AIP CANADA (ICAO) SUPPLEMENT 50/18

BUTTONVILLE CONTROL ZONE AND TORONTO TERMINAL CONTROL AREA CHANGES TORONTO, ONTARIO

(Replaces AIC 23/18)

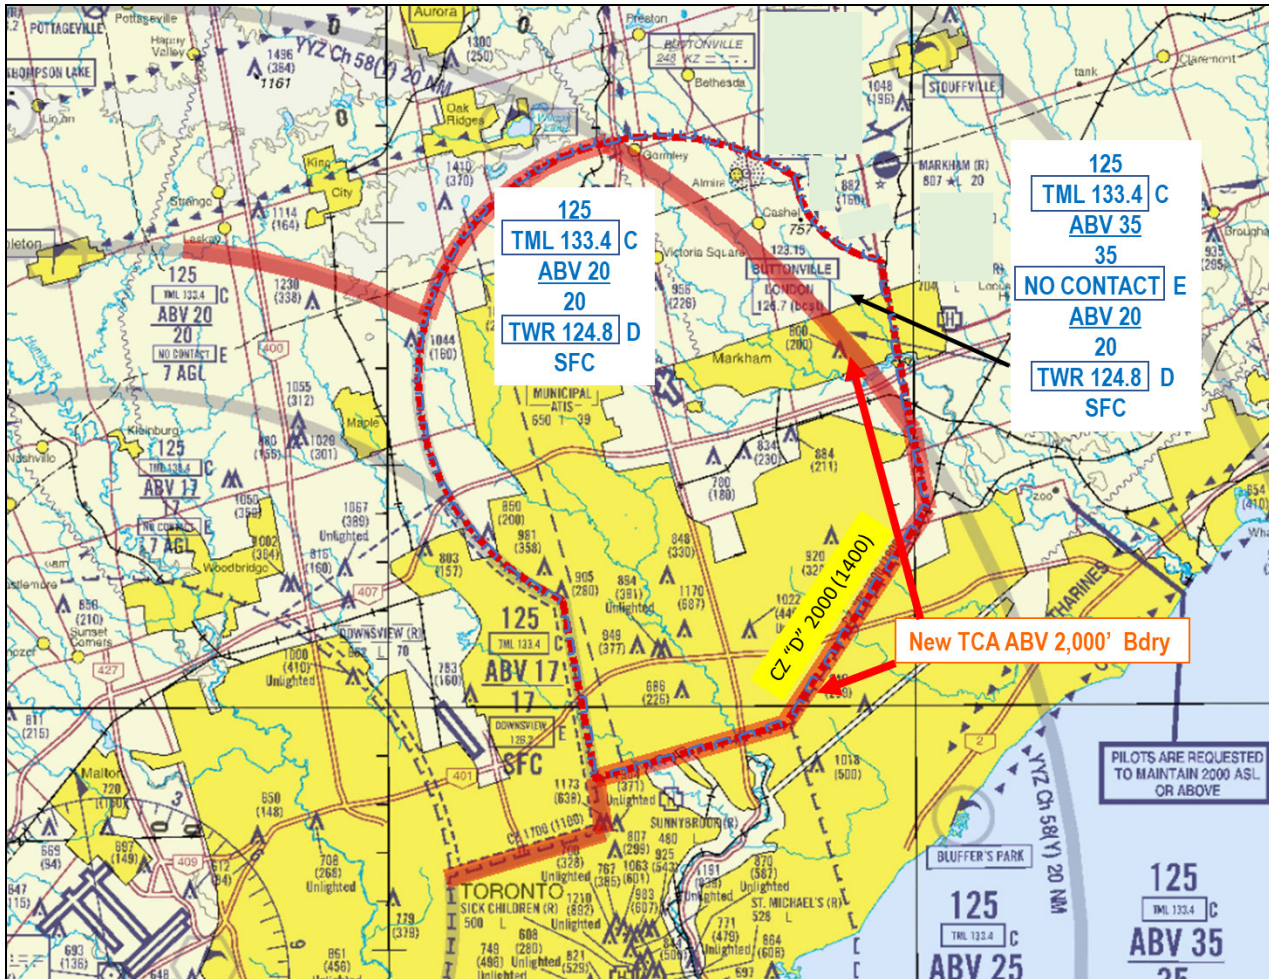
To enhance aircraft traffic management at the Toronto Lester B. Pearson International Airport (CYYZ), the ceiling of the Buttonville control zone (CZ) will be lowered to 2,000 feet above sea level (ASL). In addition, the 2,000-foot ASL Toronto terminal control area (TCA) boundary is being expanded to encompass most of the Buttonville CZ (see map sketch below).

This change takes effect 13 September 2018, at 0901Z Coordinated Universal Time (UTC). Refer to this AIP Supplement until the amended Toronto visual flight rules (VFR) terminal area chart (VTA) (AIR 1900) is available in Spring 2019.
